A sketch for new gate & brick entrance path.

A proposal for
FITZROY SQUARE, LONDON, W1

Revision 13.05.14

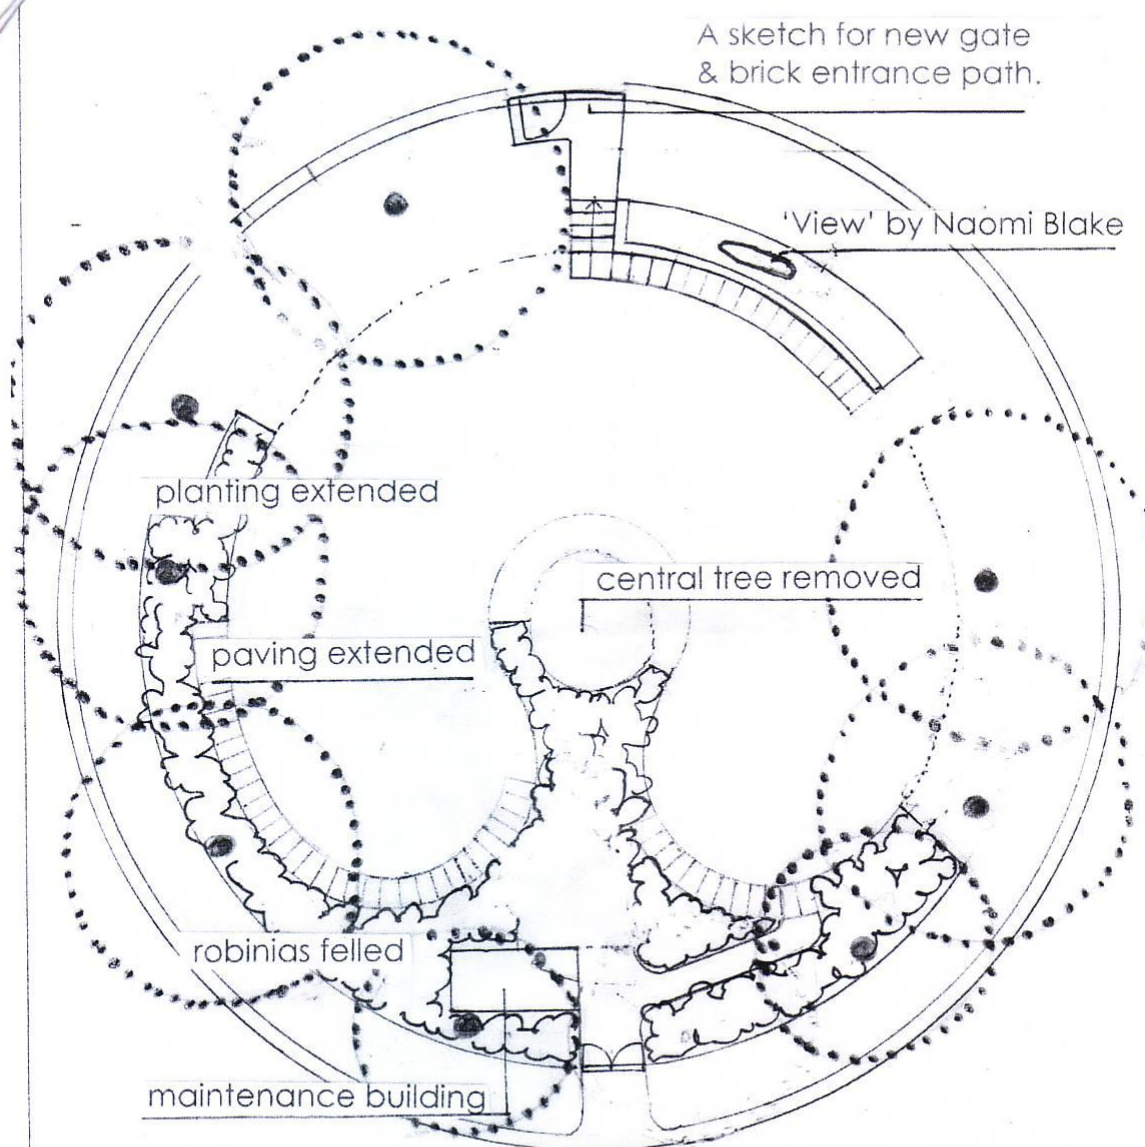
planting extended

central tree removed

paving extended

robinias felled

maintenance building
